# The courtyard as the family's haven · a study in phases · Phase 0: the facts · Taif / Palm House V10.0

The owner's brief (10 Nov 2026): breeze, water, tree, shade, winter sun, views, privacy, calm, beauty, easy upkeep, all working together; find every mistake. **Locked:** the site and the outline, the structure, the stair and the lift, the settled rooms, the malqaf L5. **Open:** the seating, the water and the tree, the outlet (A or B), the sink window, the courtyard's doors and windows, the arch infill, the lighting, the floor, the planting, the drainage. **Owner's preferences:** no TV; every seat with a back, 5–6 seats; open to the sky; level floor, movable furniture; render and paint, porcelain floors; simple switches; privacy only from the guest route and the majlis side. **Amber = an assumption.** Phase 0 cites the files; Phase 1 checks them.

# Phase 1 · the 22 checks (and the owner's two notes) · pass / fail / unknown, with the numbers

# Phase 2 · the mistakes, ranked · why each matters and how big it is · what the open items can fix

H1 · fixes in place

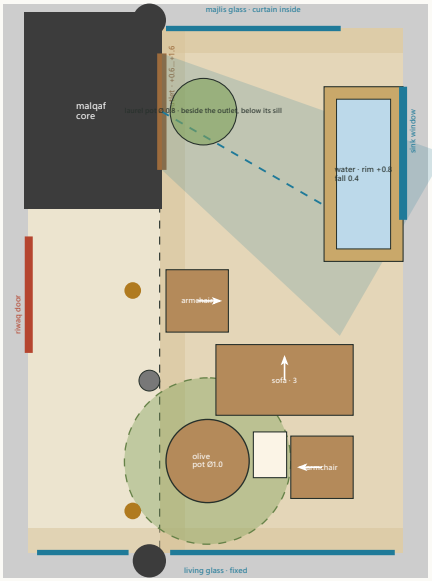
**H1 · fixes in place** the outlet A kept (its louvres set low, along the floor); the water re-made where it is; the olive; the seats turned to the water

- **Outlet:** A as built: low; the louvres fixed 40° south-east and 10° down so the jet runs along the floor to the kitchen wall, not at the faces
- **Water:** a basin 1.3 × 1.3 on the kitchen wall under the sink window: a wall spout at +1.00 falls 0.45 into water at +0.55, rim +0.70; a skimmer basket at the overflow; the pump in a dry chamber under the spout

- **Seats (5):** sofa · 3 facing N, armchair facing E, armchair facing W the table 0.4 × 0.55 under the olive's head.
- **Light:** the two lanterns (soffit) + a submerged warm light in the basin + two low wall lights on the kitchen wall's plain part (a 2700 K strip behind the jasmine wire); one switch by the riwaq door, one dimmer

H2 · the breeze over the water (outlet B)

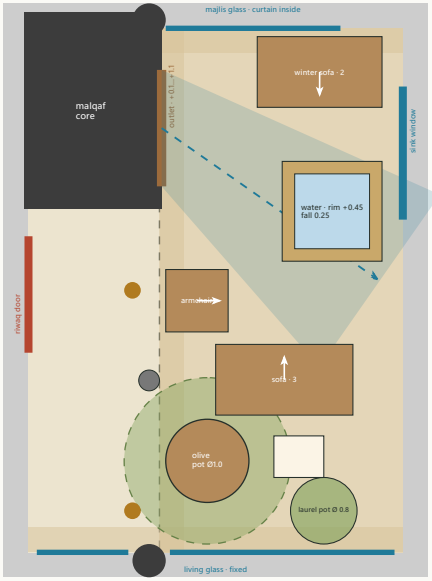
**H2 · the breeze over the water (outlet B)** the outlet raised and turned at the water; the water a long trough along the kitchen wall in the jet's path; the seats in the spill facing the water

- **Outlet:** B: raised, centred in the bay, the louvres fixed 30° south-east with splayed reveals: over the trough's rim and under the olive's head
- **Water:** a trough 2.1 × 0.95 along the kitchen wall under and south of the sink window: a wall spout at +1.05 at its north end falls 0.40 into water at +0.65, rim +0.80 (the sill +1.10 above it); the skimmer at the south end where the flow ends; the pump in a dry chamber

- **Seats (5):** sofa · 3 facing N, armchair facing E, armchair facing W the table 0.4 × 0.55 under the olive's head.
- **Light:** as H1, plus a light under the trough's spout; the olive up-lit from the floor

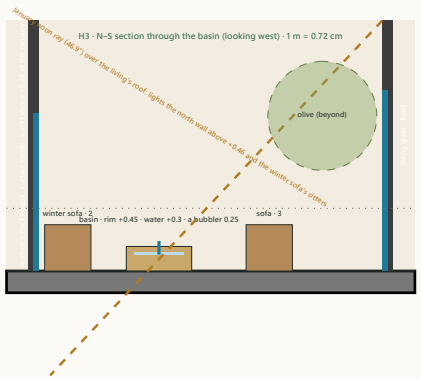
E–W through the outlet's axis: the jet +0.6…+1.6 over the trough's rim +0.80 and under the olive's head +1.8; the spill down the kitchen wall onto the sofa
